**Grounding cable for electronic module of
ROTAX Engine Series Type 912 A**

Mandatory

Subject: Inspection of electronic module on engine series 912 A. Specifically, review cable lug connection onto grounding cable.

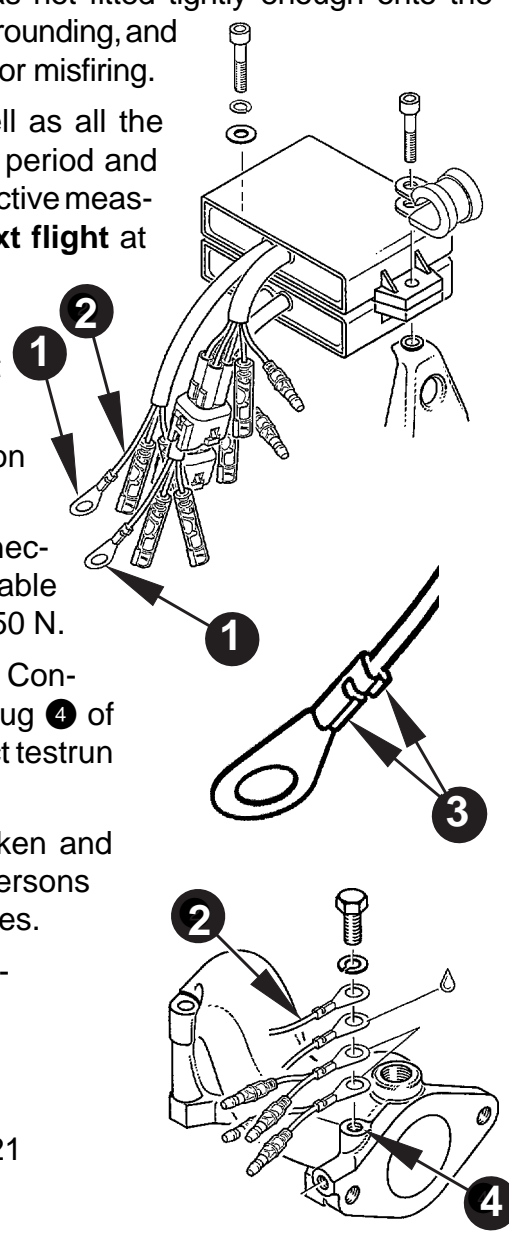
Reason: Production machinery problems may have caused inadequate cable assembly on electronic module, part no. 965 356.

In some cases the cable lug ① was not fitted tightly enough onto the grounding cable ②, resulting in poor grounding, and possibly leading to engine stoppage or misfiring.

Remedy: To guarantee the sufficient crimping ③ of the cable lug a pull-off test with 50 N has to be conducted.

◆ **NOTE:** The specified extraction force is 100 ÷ 200 N.

At occurrence of an inadequate connection, correct by crimping on new cable lug, part no. 964 056 and test with 50 N.

Apply Lithium grease on cable lug. Connect both grounding cables ② on lug ④ of the right intake manifold and conduct testrun and ignition check.
